**ADDENDUM NUMBER:** FOUR (4)

**DATE:** February 20, 2026

**PROJECT:** LONE OAK COMMUNITY CENTER

**TO PLANHOLDERS:** This addendum is issued to modify the original Project Manual and Project Drawings, dated January 30, 2026 and is hereby made part of the contract documents. Acknowledge receipt of this Addendum in the space provided on the Bid Form. Failure to do so may subject the Bidder to disqualification.

# D1.1A

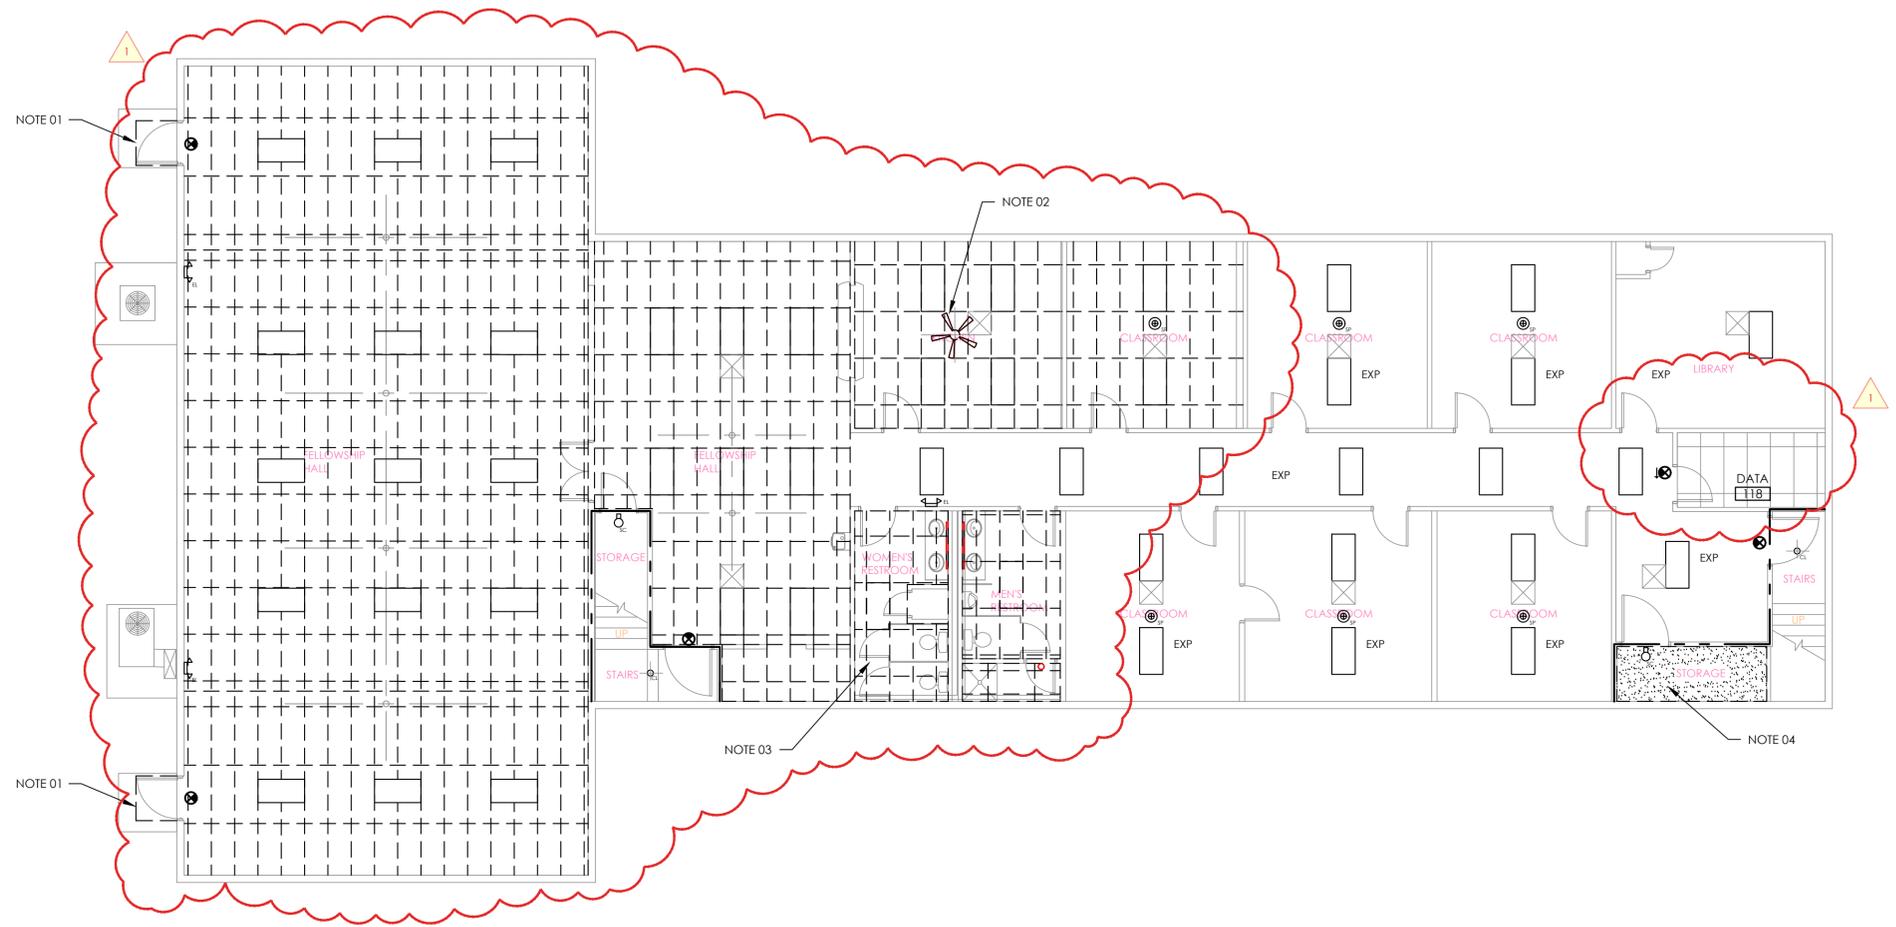
3. Sheet D1.1A Add Alternate #2: Lower Level Demolition Plan delete sheet dated 02/13/2026 and replace with sheet dated 02/20/2026
  - a. Revised Key Note 05
  - b. Revised Key Note 06
  - c. Revised General Notes – added two (2) new notes
  - d. Enlarged dimensions to be seen
  - e. Added in wall in Data Room and door into Library to show as existing

# A1.1

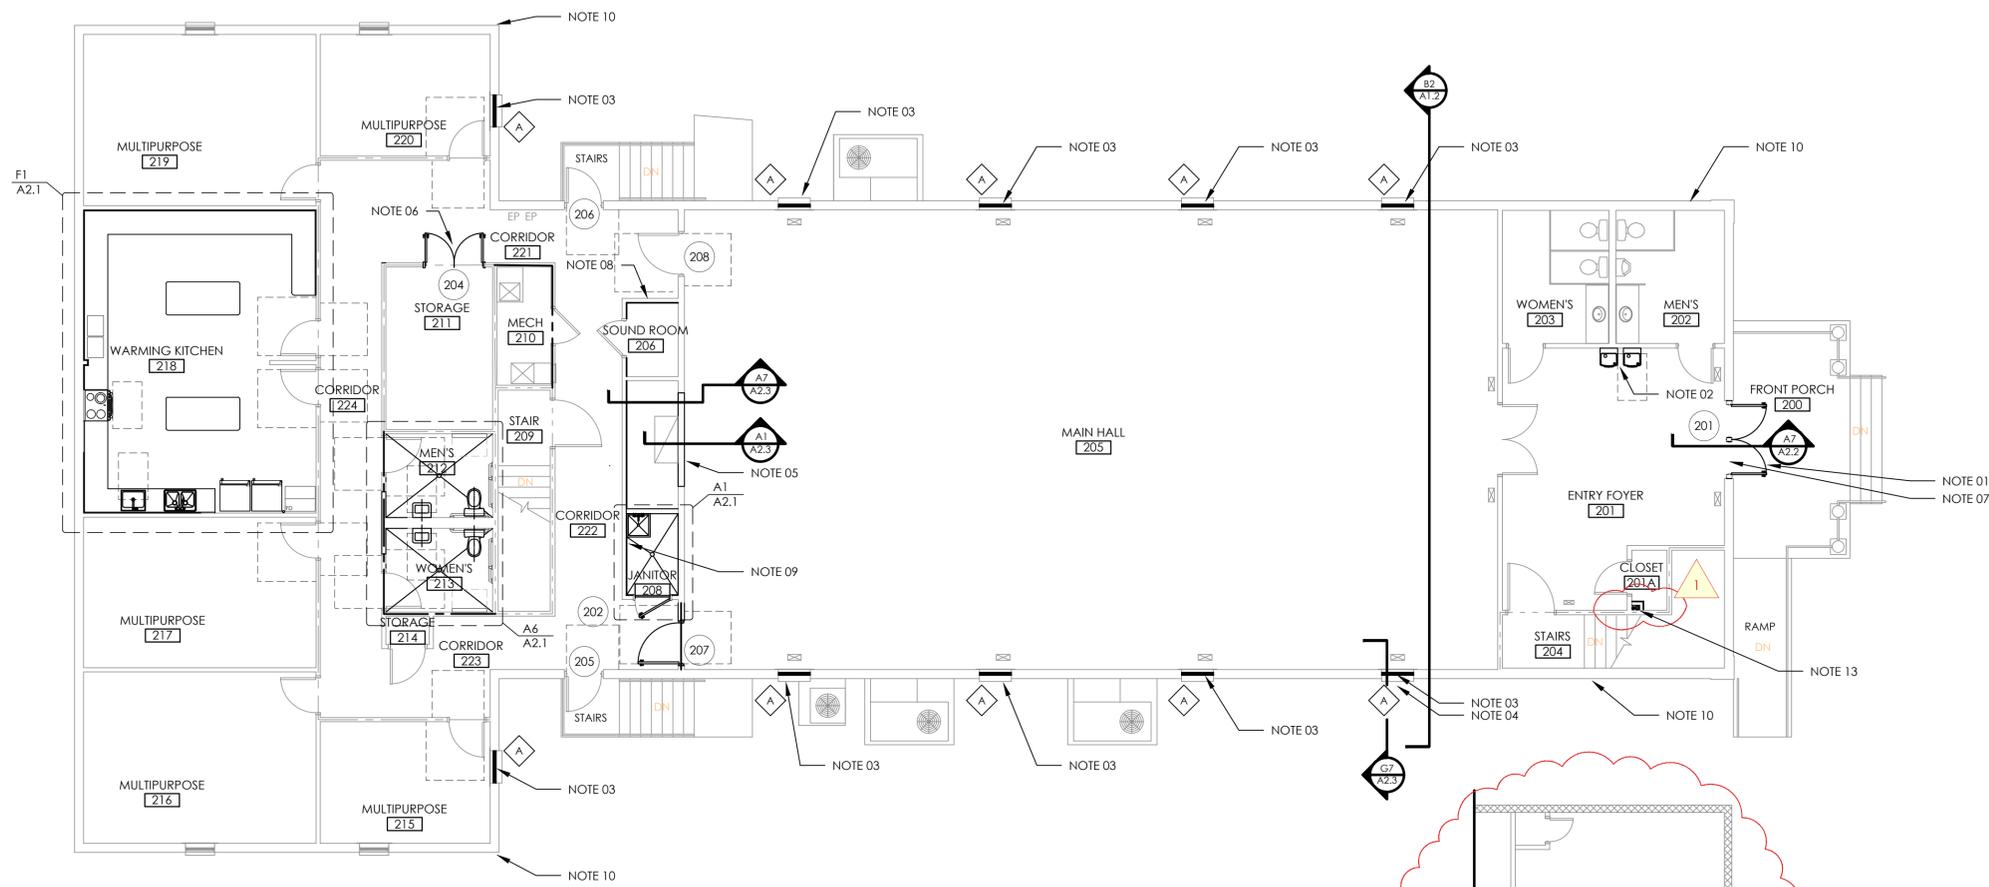
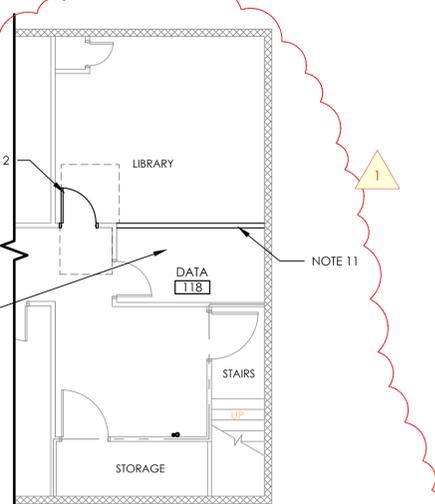
5. Sheet A1.1 New Construction Plan delete sheet dated 02/13/2026 and replace with sheet dated 02/20/2026
  - a. Added Key Notes 11, 12, 13
  - b. Added lower level Library Plan
  - c. Show creating new Data Room 118 to the Base Bid
  - d. Added in Electrical Notes for new Data Room
  - e. Show where new 5" x 8" electrical chase is being created in Closet 201A

**A1.1A**

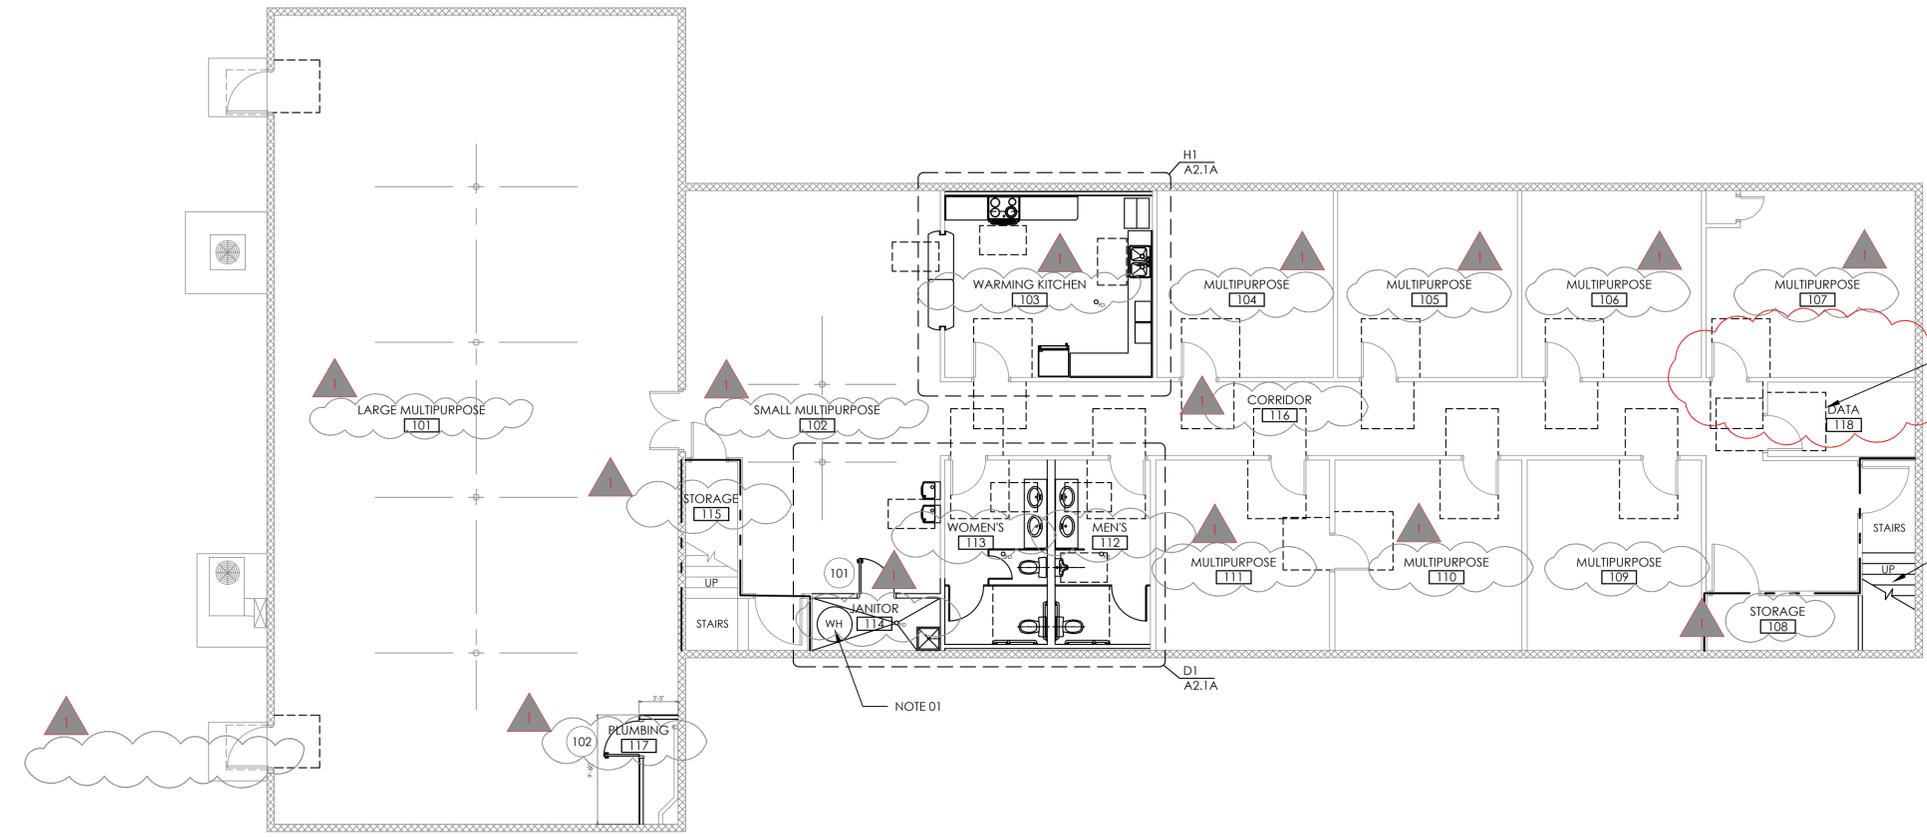
6. Sheet A1.1A Add Alternate #2: Lower Level New Construction Plan delete sheet dated 02/13/2026 and replace with sheet dated 02/20/2026
  - a. Show Data Room 118 as existing

**A1.2**

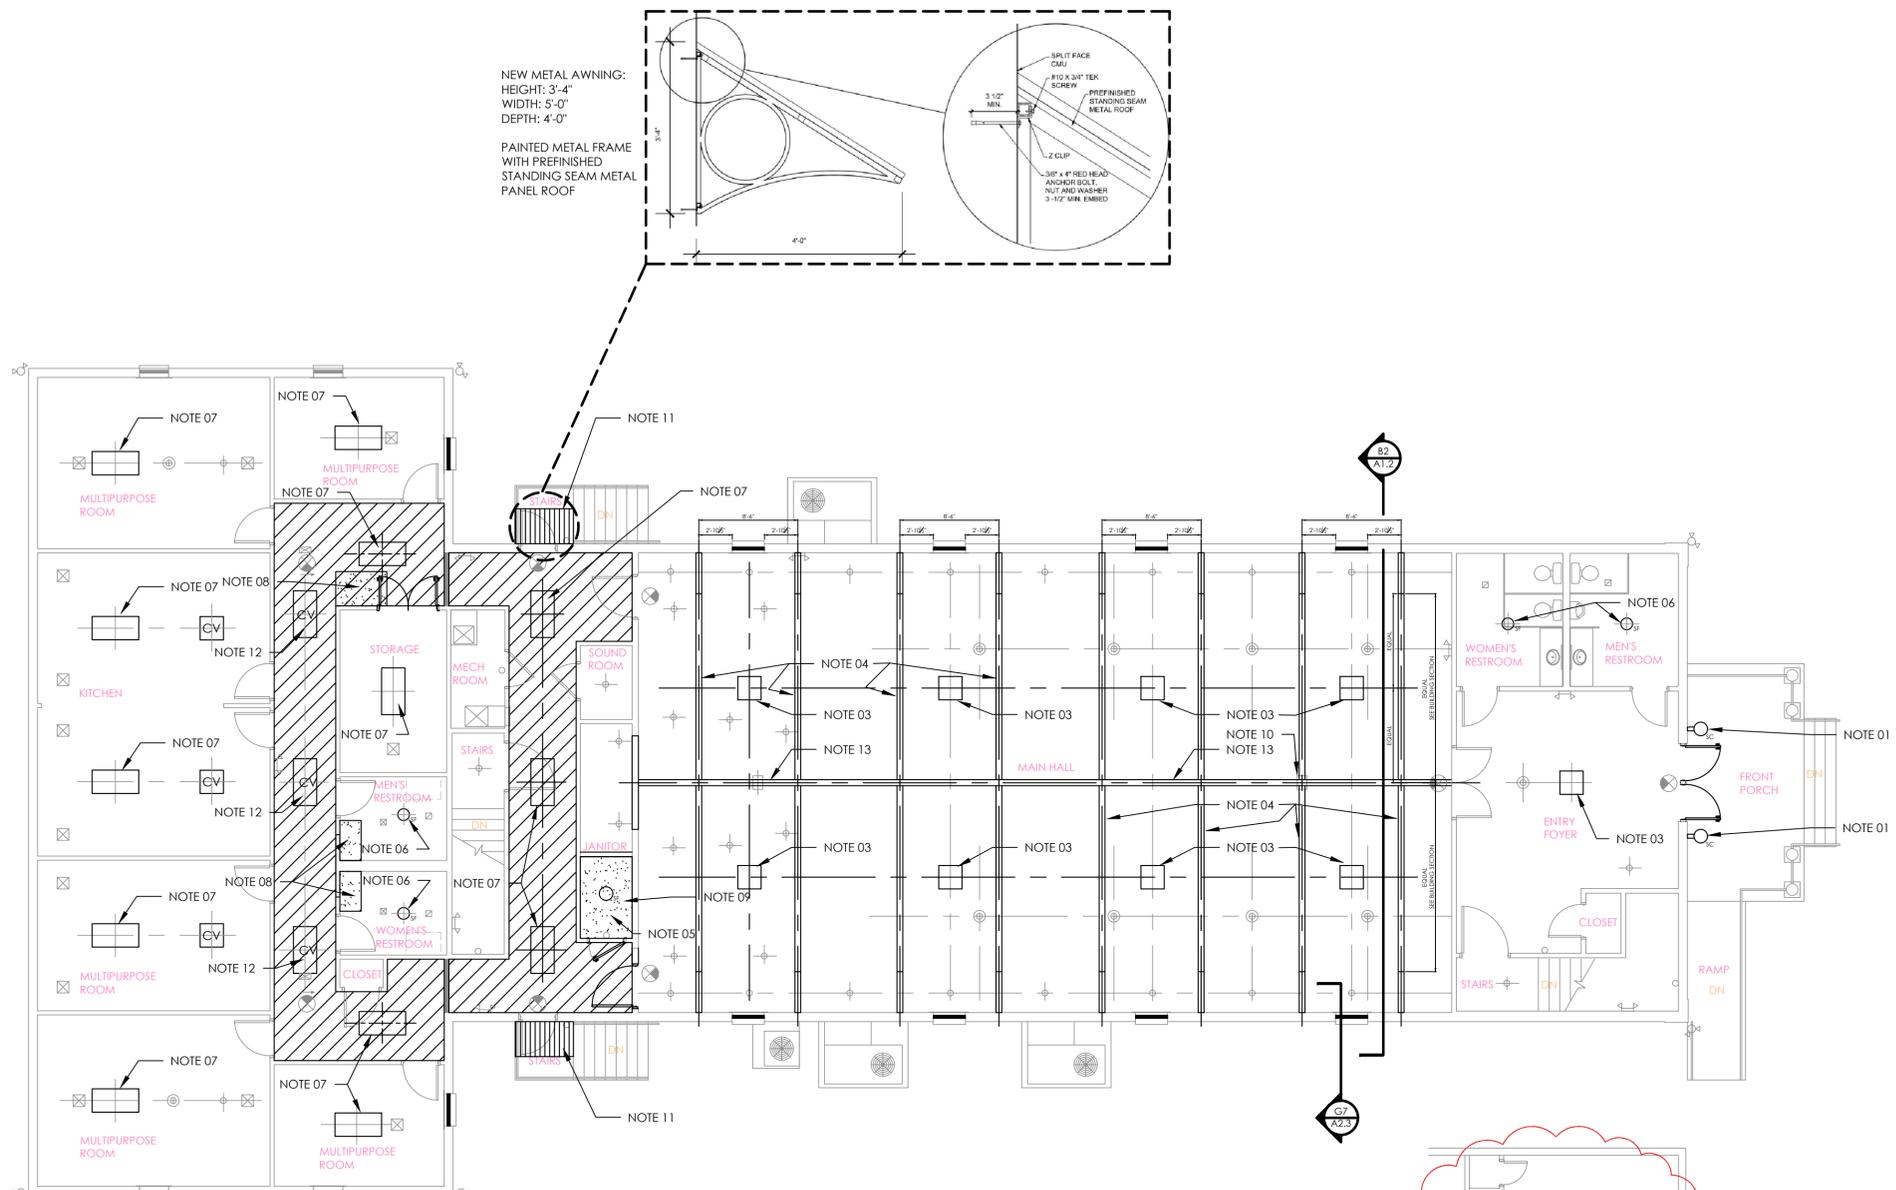
7. Sheet A1.2 Reflected Ceiling New Construction Plan delete sheet dated 02/13/2026 and replace with sheet dated 02/20/2026
  - a. Added new General Notes
  - b. Added new Project Notes 14, 15, 16
  - c. Show new ceiling plan in Lower Level Data Room 118

**M1.1**

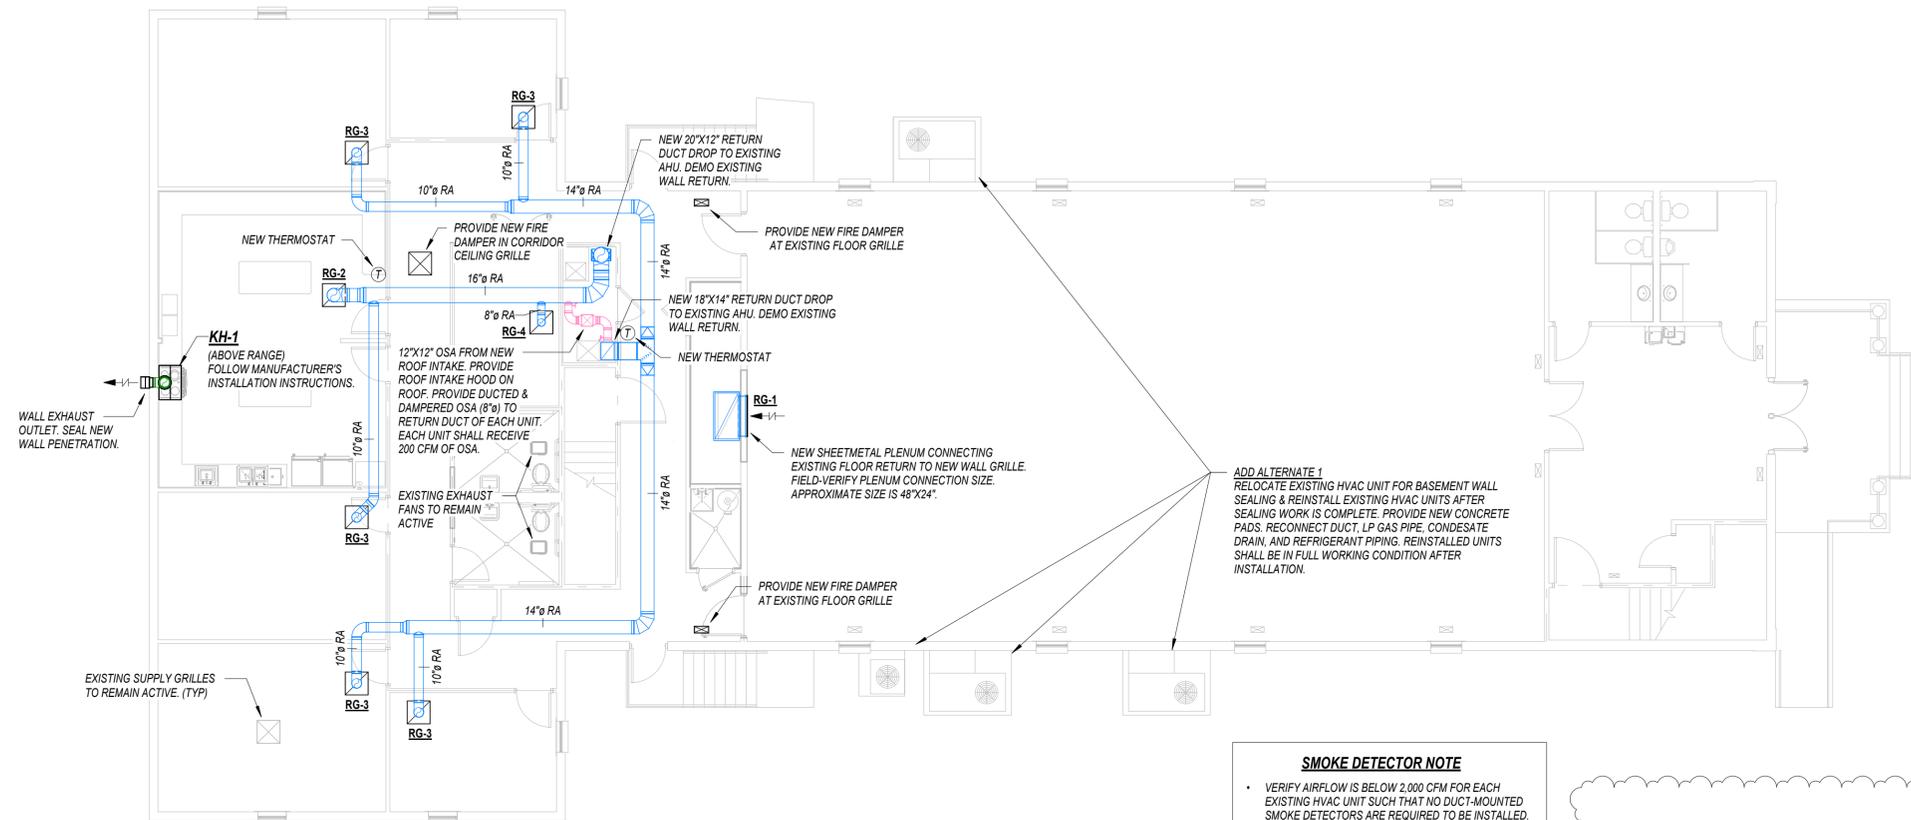
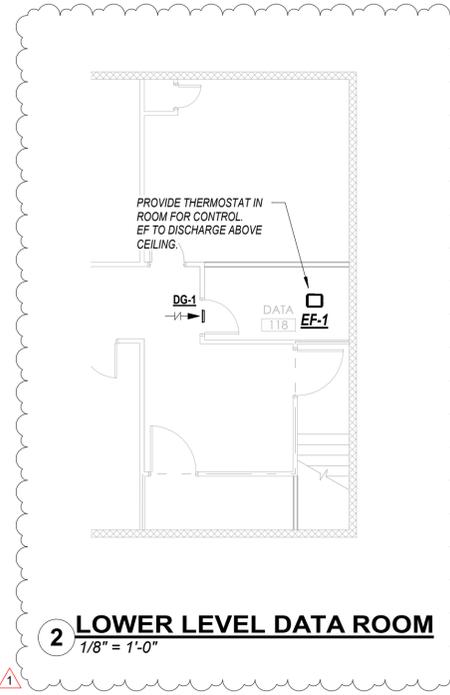
1. Sheet M0.1 HVAC Schedules and Notes delete sheet dated 02/13/2026 and replace with sheet dated 02/20/2026
  - a. Added Exhaust Fan Schedule
2. Sheet M1.1 HVAC Plan delete sheet dated 02/13/2026 and replace with sheet dated 02/20/2026
  - a. Add drawing and notes for lower level Data Room 118
